Liddell Road – Block A – Roof plant

Issue:	001
Date:	10 th January 2024
Reference:	P22-008/RPT/JS/Information

Mecserve has been requested to provide a report clarifying reasons for a significant MEP redesign of Block A at Stage 4, mainly with regards to the revised plant location which has led to the requirement for an acoustic roof enclosure.

The below illustrates the Stage 3 plantroom design proposed by Synergy for this area:

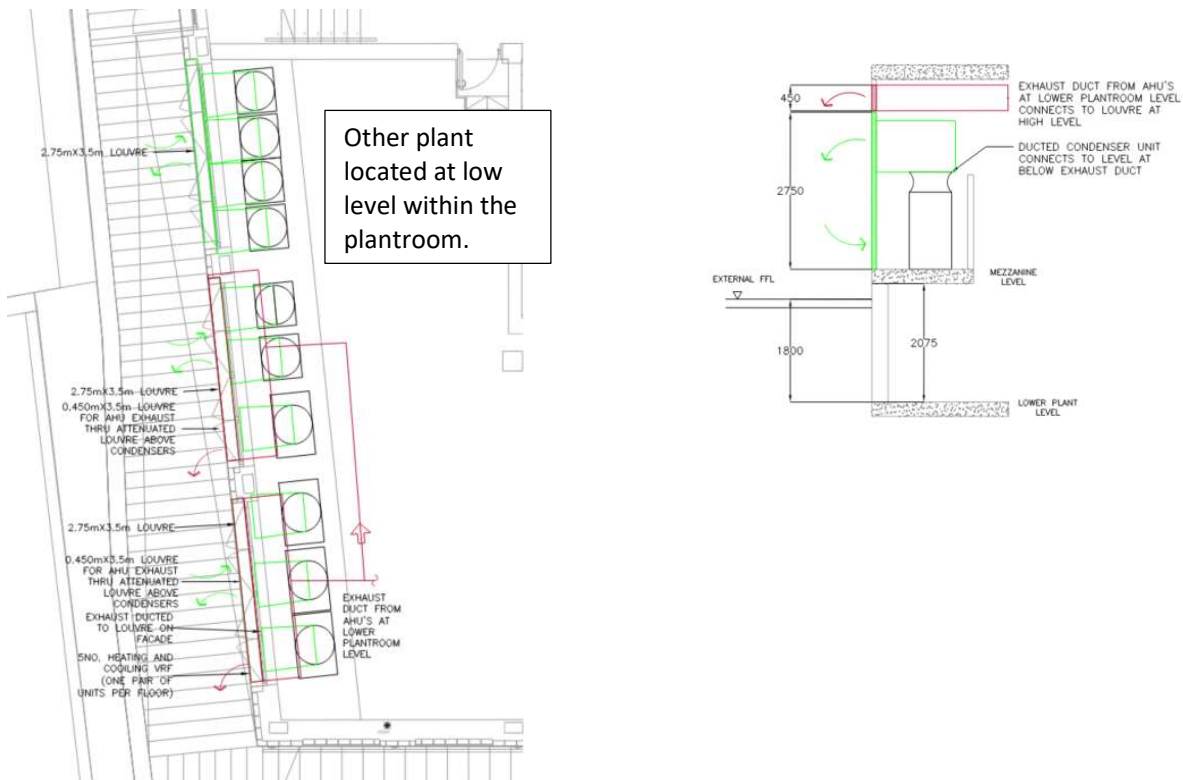
Following the review, Mecserve raised the following concerns:

- Insufficient space for the plant, including associated AHU attenuation and duct routes.
- Insufficient space and height for VRF units discharge attenuation
- Insufficient space for VRF unit's inlet attenuation
- Significant risk of the cold air being discharged during the heating cycles short circuiting back into the plantroom.
- Insufficient plant space overall to accommodate the plant serving the building.

Based on the above Mecserve, as the only viable solution available proposed to relocate the VRF condenser units to the roof. This proposal has been raised via an RFI#16 on 22nd April 2022.

Extract from RFI#16 shows stage 3 proposal for roof plant & enclosure shown below.

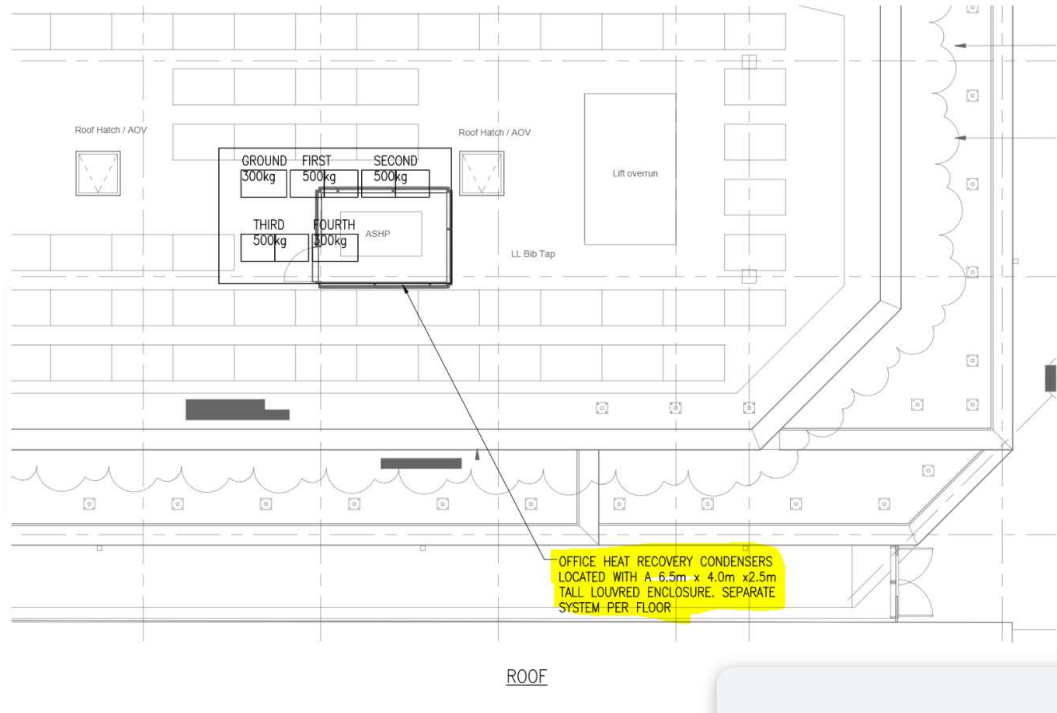
The plant selection and associated noise levels were provide to NRG for their initial noise assessment. Following the review NRG advised that a standard acoustic louvre plant enclosure as proposed in the revised stage 3 drawing provided in RFI#16 would not provide a sufficient level of noise attenuation. The only solution to meet the planning acoustics requirements was to fully enclose the plant in an enclosure, with sides and roof top being fully attenuated.

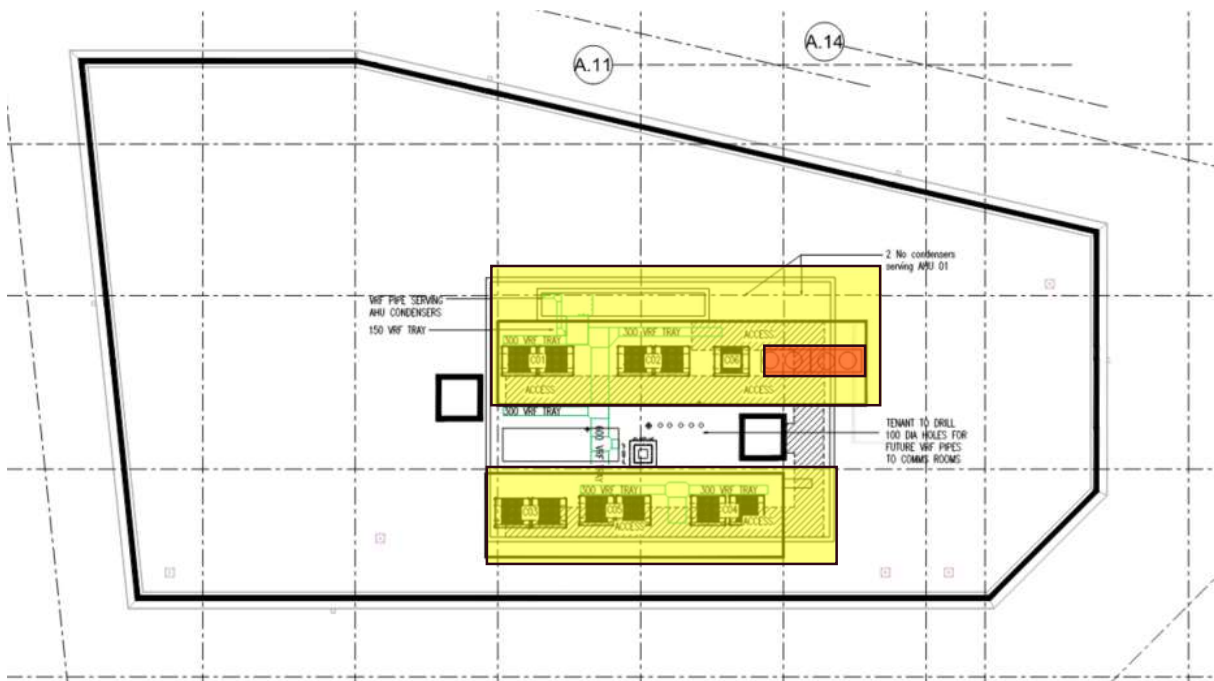
The initial assessment indicated that the enclosure would require at least 3m long attenuators sitting above a 3m plant louvre with a risk of still not achieving the noise criteria. Due to the lift overruns & access hatches impeding the space allowed for the condensers, overall size of this enclosure would be circa 10.1m by 7.5m, with a height of 3.6m.

Following this feedback, Mecserve proposed to locate the remaining plant in two dedicated enclosures away from each other as shown on the sketch below:

This arrangement was evaluated again by NRG indicating that the same level of attenuation would be required for two separate enclosures. The assessment also indicated that the unit serving AHU DX coil could not be attenuated any further regardless its location on the roof (marked in red), and remained above the planning acoustic requirements.

Mecserve decided to remove DX unit serving the AHU from the roof and replace it with an integral heat pump located within the AHU in the GF plantroom. This was originally not considered due to previously highlighted spatial constraints within the plant room.

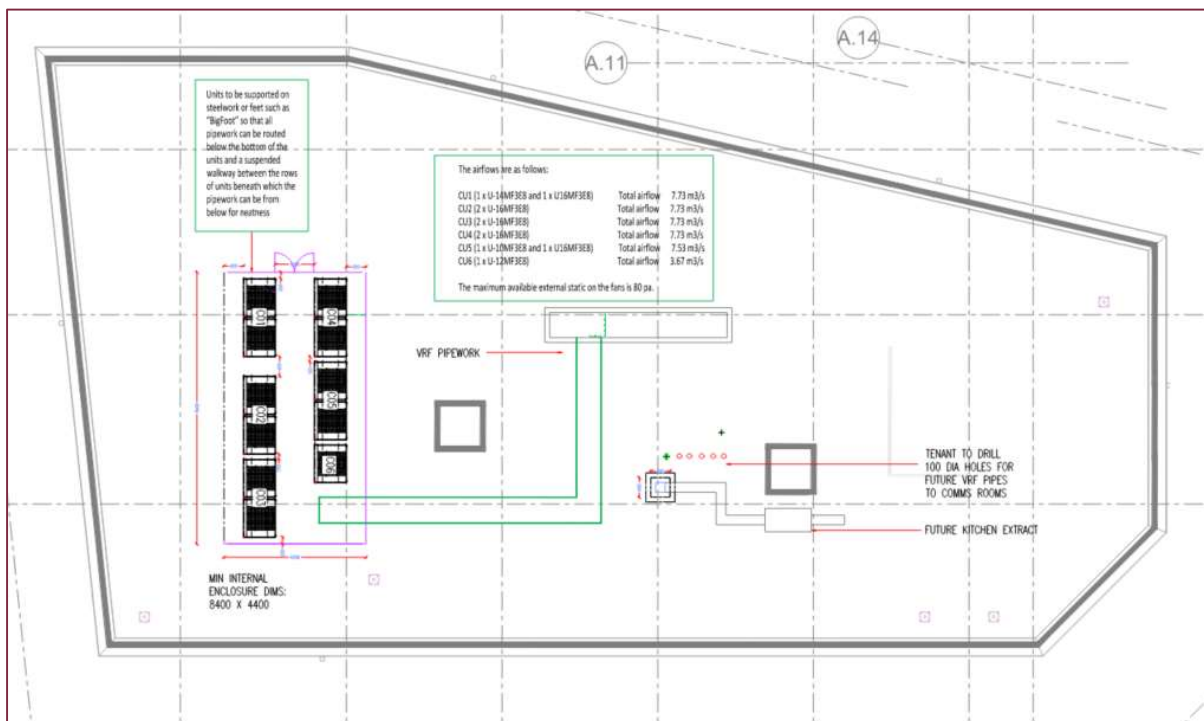
The two enclosures under this proposal were circa 10.1m by 3m x 3.6m high each.

On further evaluation of this proposal with 2 separate enclosures, it was found that the routing of pipework from the AC riser to the 2nd enclosure and maintaining safe maintenance access from the access hatch was difficult to achieve, this enclosure would have been circa 1m from the parapet on the south elevation. Additionally, the route for the future kitchen extract would be impeded and the location of future VRF to the comms room would be affected.

Following this review and the removal of the 2no. units serving the AHU's and incorporating them into the AHU's in the plantroom, Mecserve & NRG carried out a number of simulations to assess the best location for the enclosure against all sensitive noise receptors. In addition, Broadway Malyan architects reviewed the visual impacts. The conclusion was to house VRF units within one single enclosure, located on the east side of the roof to meet the noise criteria. this enclosure size is 9m x 5m x 3.6m high(at highest point). This location sets the enclosure back to a minimum of circa 3.5m from the parapet.

The reason from the increase in enclosure size from the stage 3 proposal shown in RFI#16 and the stage 4 requirements is due to the free area for the air path being limited by a significant amount of attenuation, the enclosure has been sized to ensure that a sufficient air flow for intake and exhaust is maintained, including minimum requirements for the plant maintenance.

- AHU shown in brown,
- Additional attenuator shown in blue.
- Sprinkler pump in green

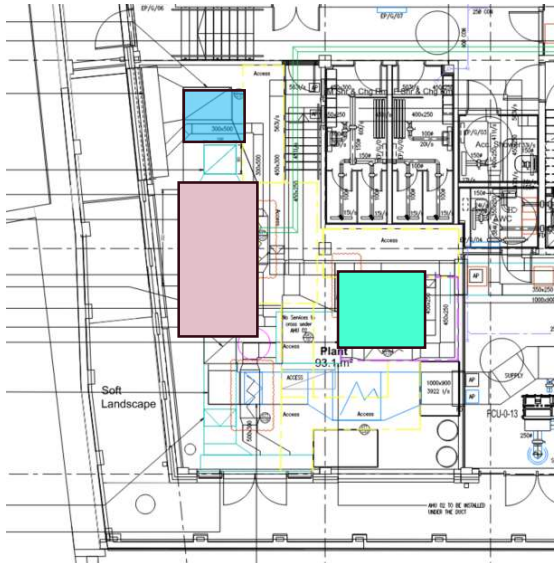
With the above proposal, as discussed previously, the AHU serving the office block is provided with an integral heat pump to temper the supply air. This has increased the length of this AHU by 800mm, the height by 400mm and required the addition of large attenuators within design of the ground floor plantroom as shown

below. As a result of these increases in size, the sprinkler tank had to be redesigned to fit into a smaller space allocation.
